19/05706/FUL - 181D Squires Lane / Land Rear of 172 Long Lane, London, N3 2RA

Formal response to case officer's e-mail dated 11 December 2019

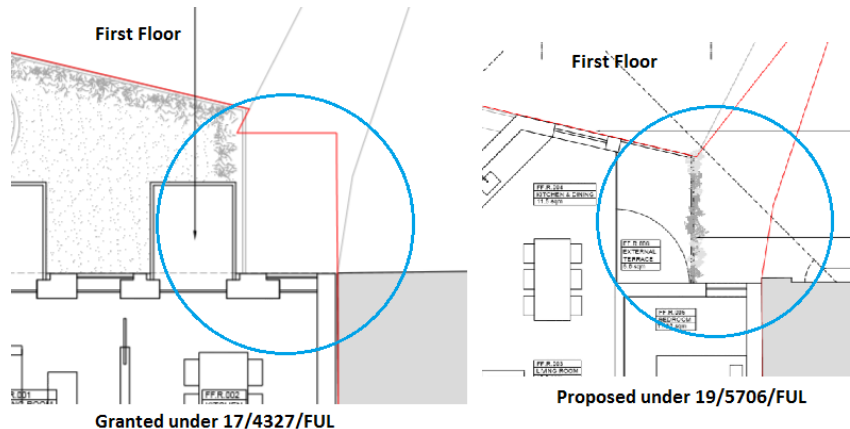
The development as a whole retains very much the same design approach as the extant permission save for the fact that we have made some modest alterations to the front elevation and infill to the side of no.183. We have sought to maintain the set-back and set-down appearance of the side infill and we contend that this still performs its functions in terms of providing for an effective transition in the mass and scale of the building from the much more dominant existing front and side elevations at no.181 to the smaller and more subservient features of the terrace building at no.183.

The mansard roof has a markedly lower eaves and ridge height than no.181 and therefore respects the transitional approach across the width of the application site. Furthermore, the massing of the proposed roof addition is situated on the eastern side of the building aligning with no.181, therefore allowing for a stepped down approach over the infill on the western side of the site to no.183. The extent of the roof addition is certainly not significant from front views of the proposed elevation or from public vantage points in-front of no.181. The stepped down transition is considered to be effective in eastward views from the west along Squires Lane.

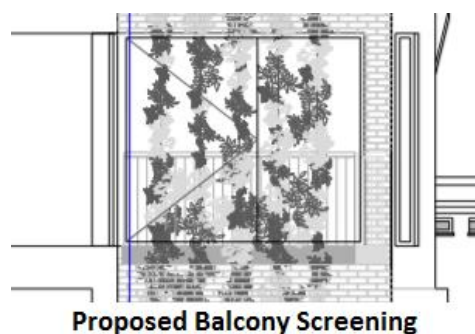
We would strongly contend that the principle of balconies in this location has already been established through the extant planning permission on the site, and this in effect could be built out at anytime until the expiration of the planning permission. The fact that the balcony in the proposed scheme is conjoined to the building along two sides makes no material difference to the extent of any actual or perceived overlooking of the neighbouring property.

We would go further to state that the degree of any perceived or actual overlooking into the rear garden of no.183 would be more severe under the extant scheme than it otherwise would be in the proposed scheme now before you for consideration. This is because there was no screening to the balconies on the extant scheme and no condition was attached to require screening to be secured and retained thereafter. Future occupiers of the extant development would have had an uninterrupted and complete view into the rear garden of no.183. Whereas, under the proposed scheme, we have devised a comprehensive screening system to prevent against such instances of overlooking.
